TECHNICAL STAFF REPORT
The Settlement At Savage Mill

Planning Board Hearing of March 16, 2017

Project Name: The Settlement at Savage Mill, Lots 1-35 & Open Space Lots 36-40

Request: To approve Preliminary Equivalent Sketch Plan (SP-15-017) for 6 single-family, detached residential lots, 29 single-family, attached residential lots (12 duplex and 17 townhomes) 5 open space lots, and other site improvements on 7.85 acres pursuant to the following Sections of the Howard County Zoning Regulations: **Section 107.0.F.** (R-ED: Residential: Environmental Development); **Sections 108.G.2. and 108.G.3.** which allow for density exchange in certain instances for R-20 (Residential: Single) zoned properties developed pursuant to R-ED district regulations; and **Section 111.1.F.** (R-H-ED: Residential: Historic-Environmental District).

WASHINGTON STREET EXTENSION ROAD PROFILE STA. 0+28.67 TO 7+92
 HORIZONTAL SCALE: 1" = 50'
 VERTICAL SCALE: 1" = 5'
 HOWARD COUNTY LOCAL ROAD
 DESIGN SPEED = 40 MPH

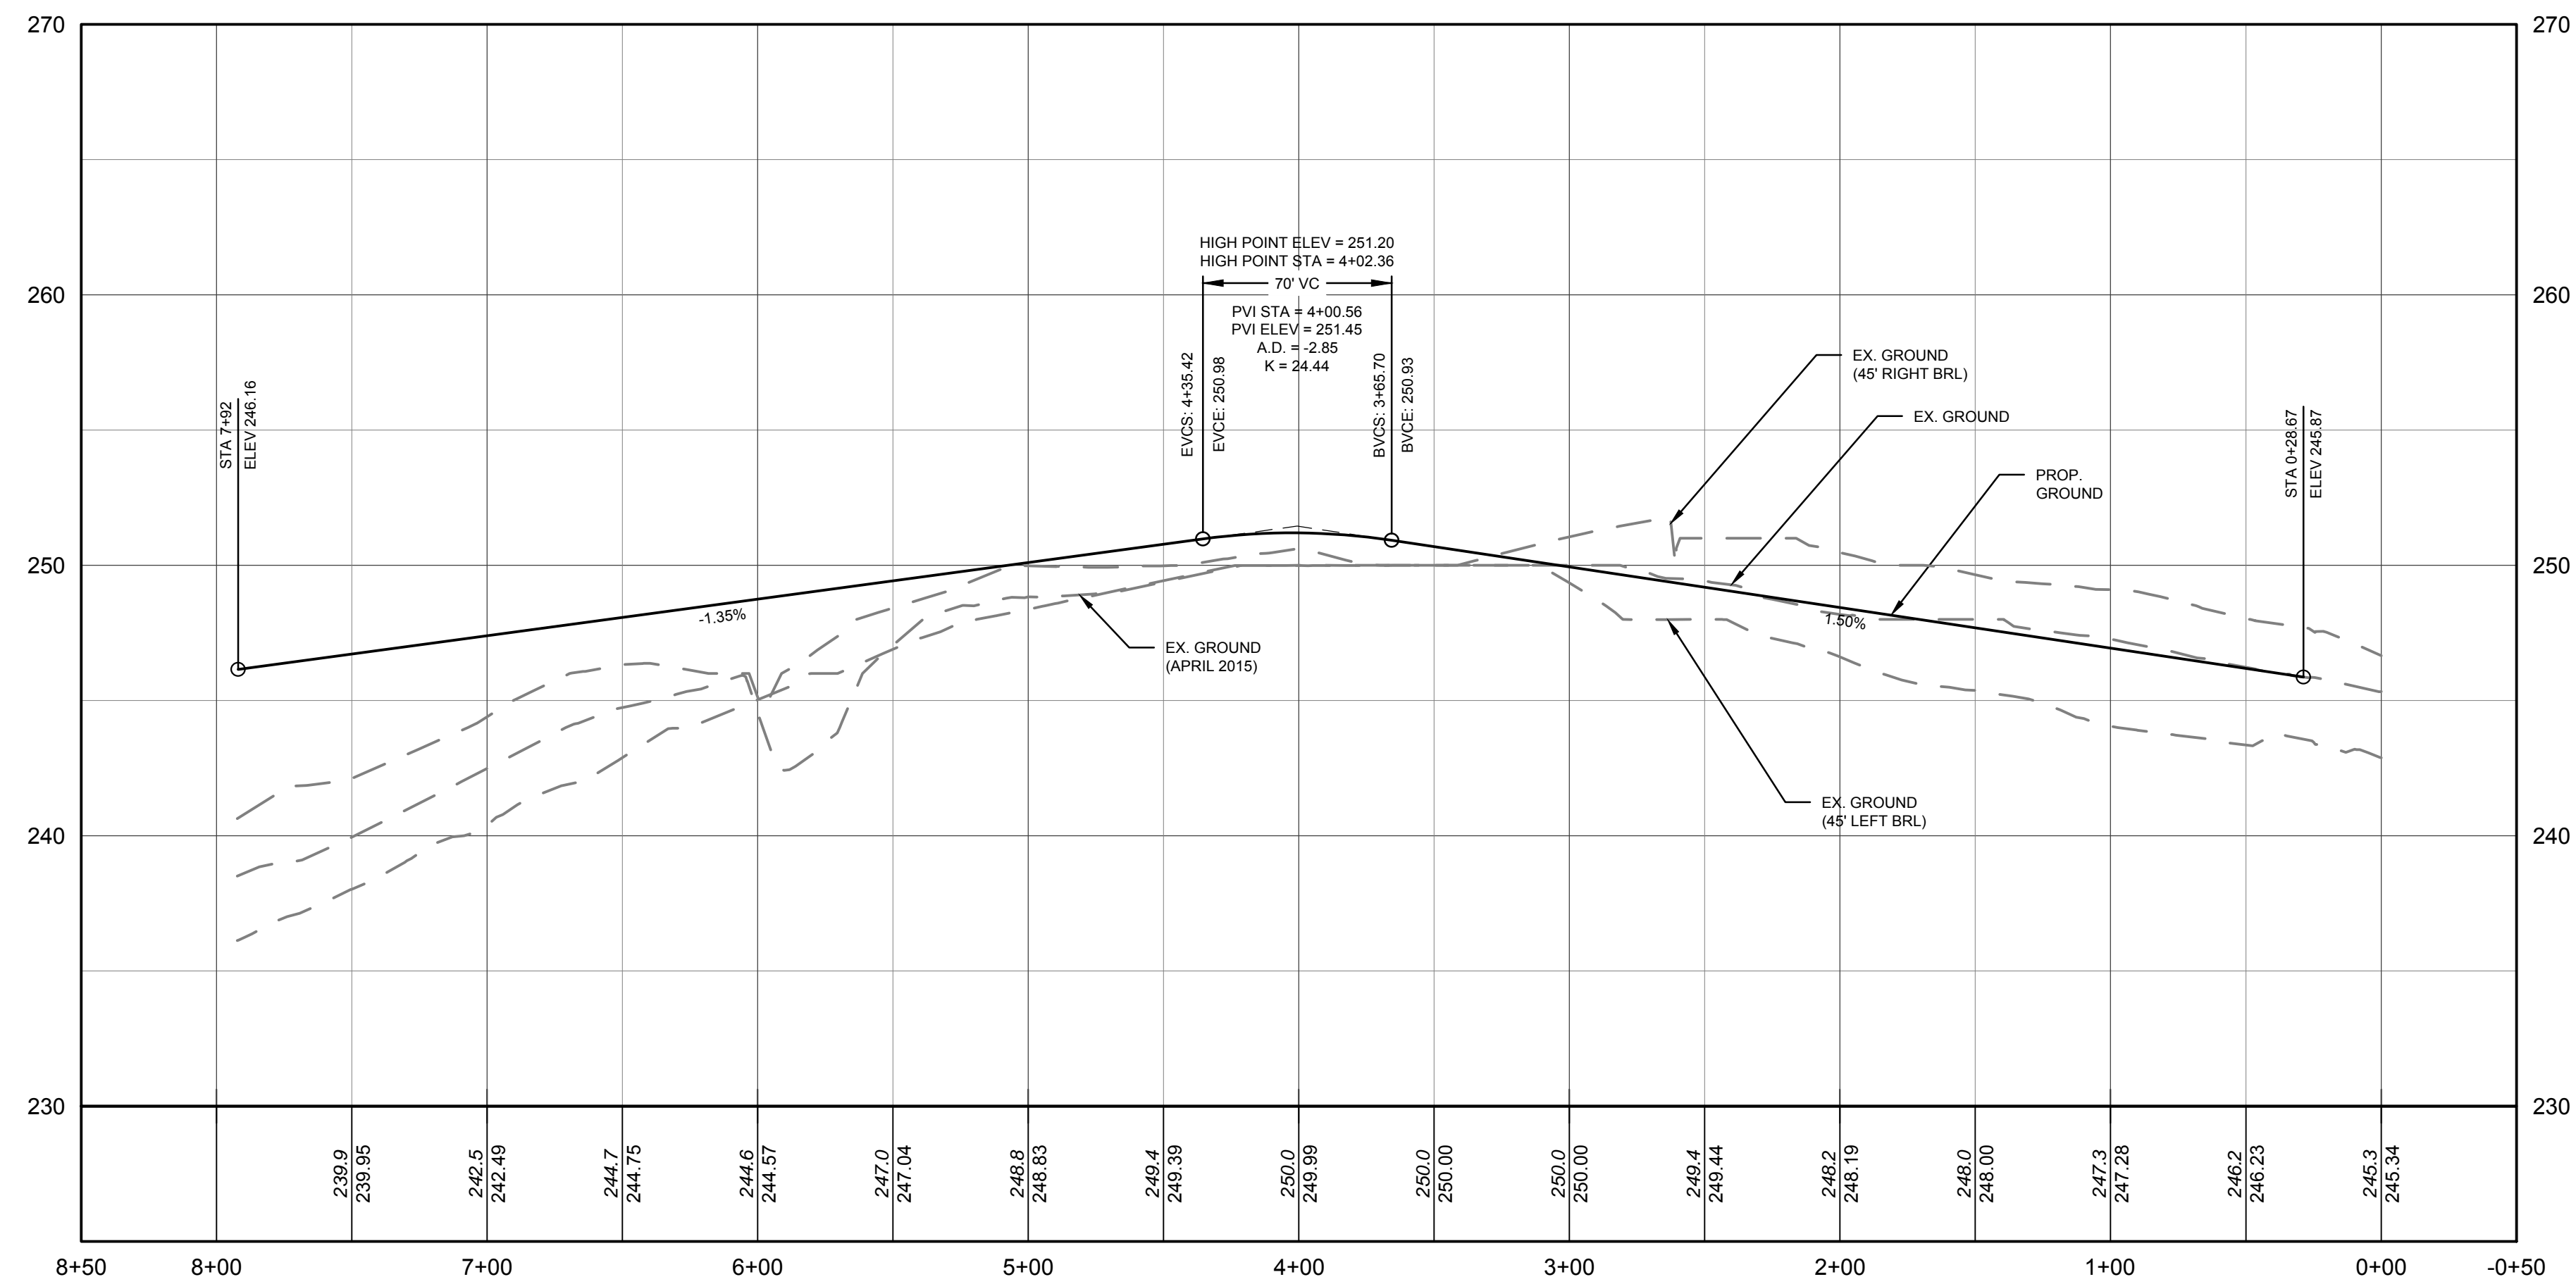
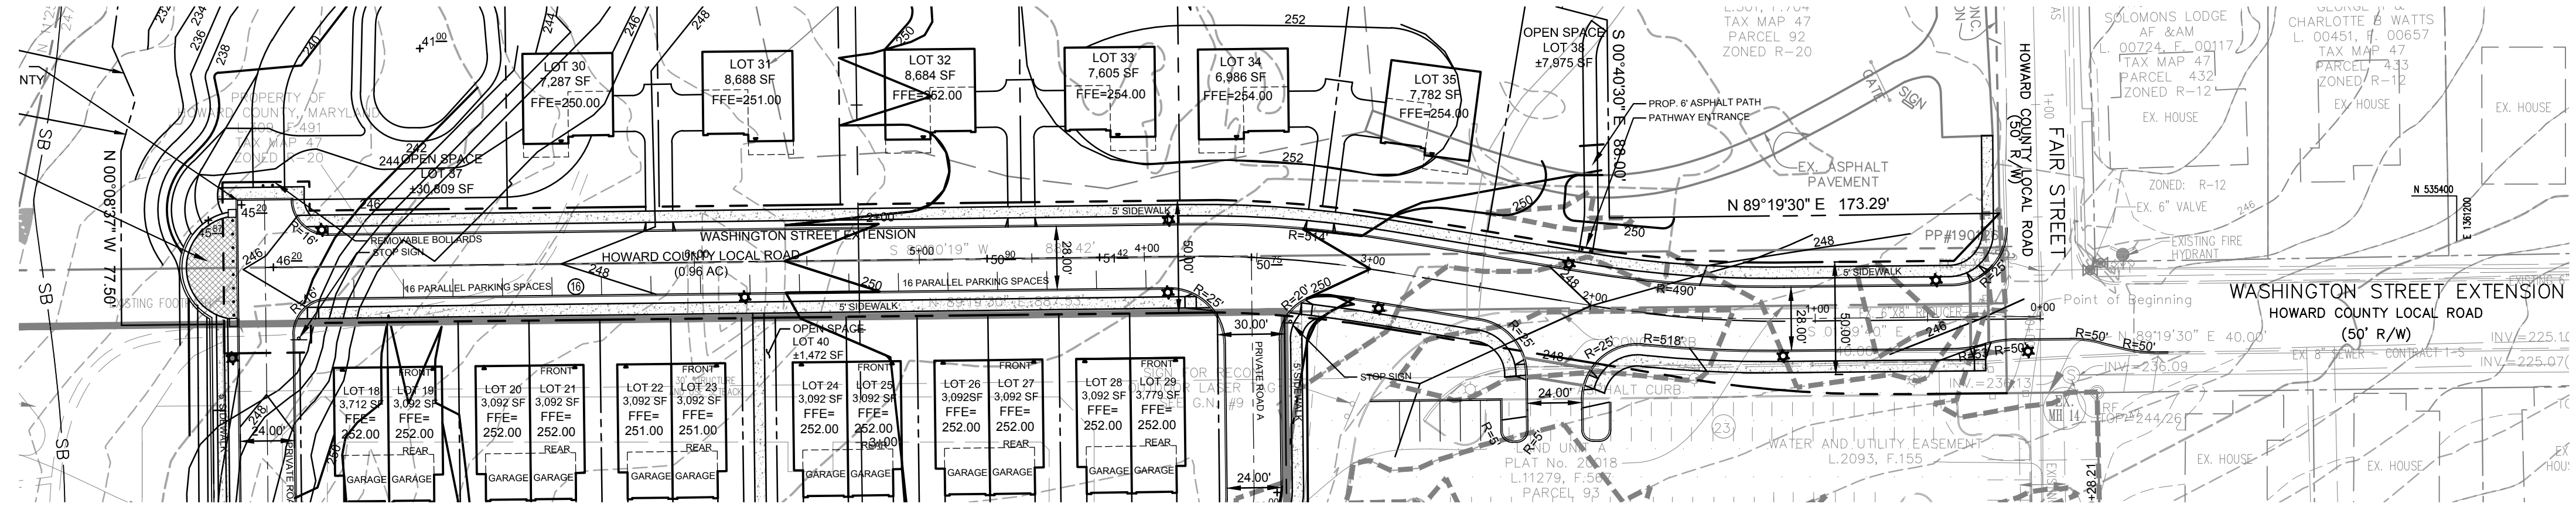
1. Please revise the Permanent Tee Turnaround of proposed Washington Street (extended) so the turnaround coincides with Specification 5.05 of Volume 4, Howard County Design Manual. Curb ramps access from/to the sidewalk entering the tee turnaround needs to be depicted. Additionally, detail of this curb ramp should be provided with the Final Plan Road Construction drawings.
